Platypus East Coast Pty Ltd

38 Stockton Street Nelson Bay DA 16-2024-581-1 RFI Flooding Response

Platypus has undertaken detailed flood modelling to provide supporting documentation to assist Coho Property in their response to RFI 16-2024-581-1 for the development of 38 Stockton Street Nelson Bay.

Title:
Peak Flood Depth and Water Level Contours
Probable Maximum Flood

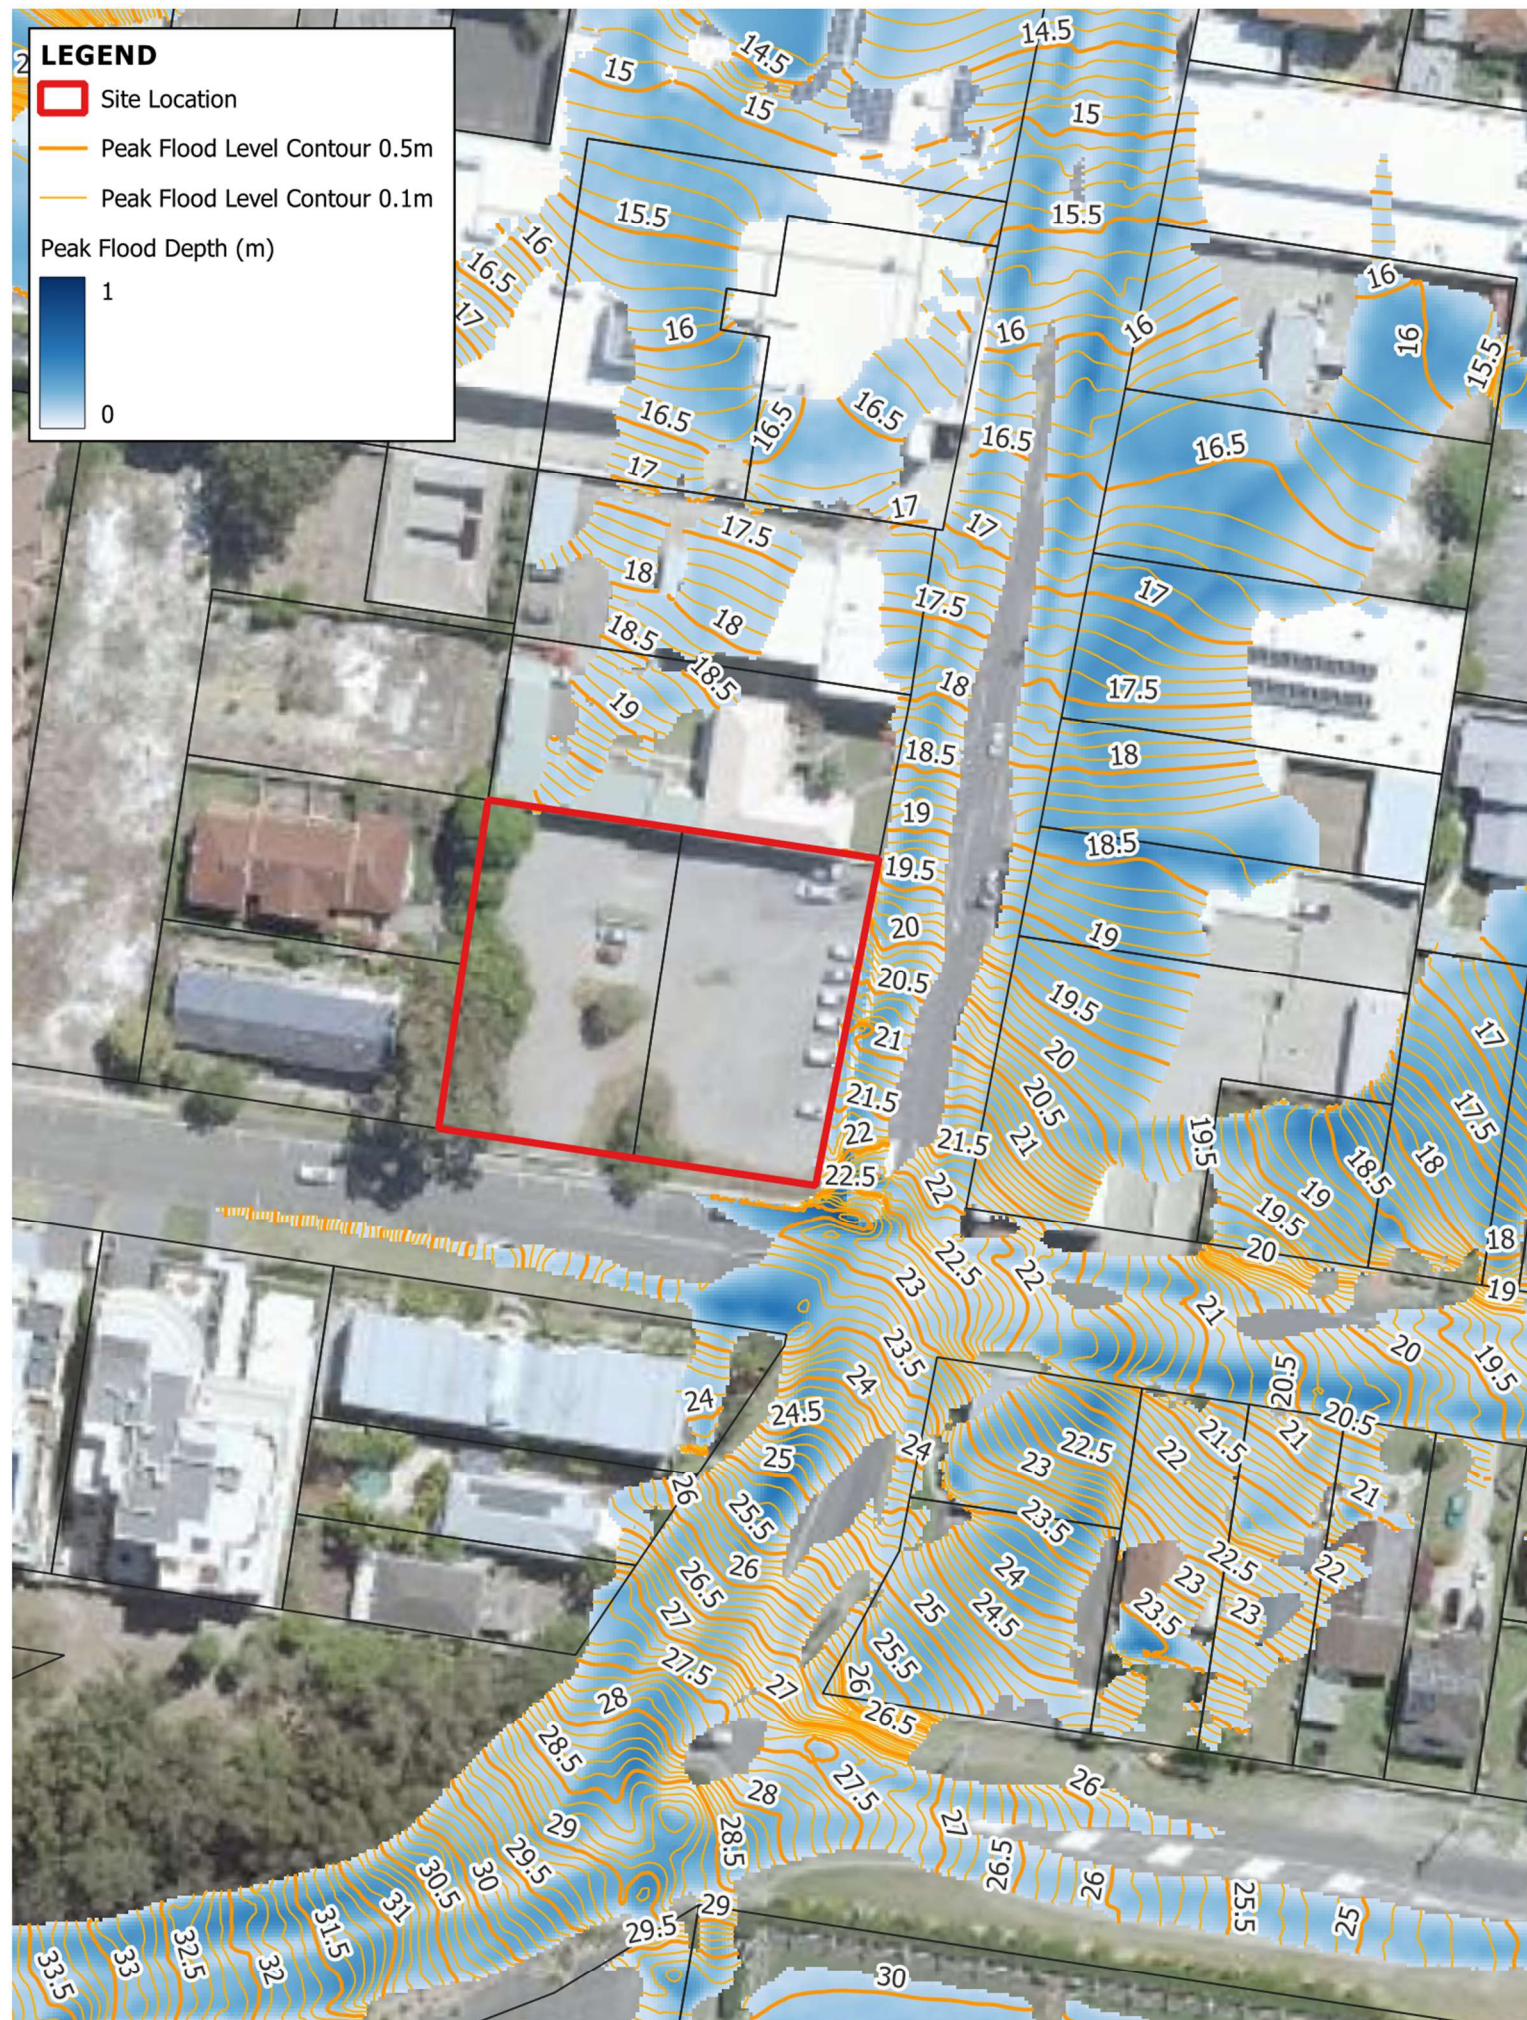
The site is flood prone. Clause 5.21 and 5.22 of the PSLEP therefore needs to be addressed. It is requested that Flood Emergency Response Strategy be provided to satisfy clauses 5.21(2)(c) and 5.21(3)(c) of the PSLEP 2013.

As demonstrated within the outcomes of the modelling, both lots are simulated to be outside of the PMF extent in the purpose built TUFLOW model. Given there is no presented risk requiring mitigation, no Prevention and Preparation is required, nor is a Response during an event.
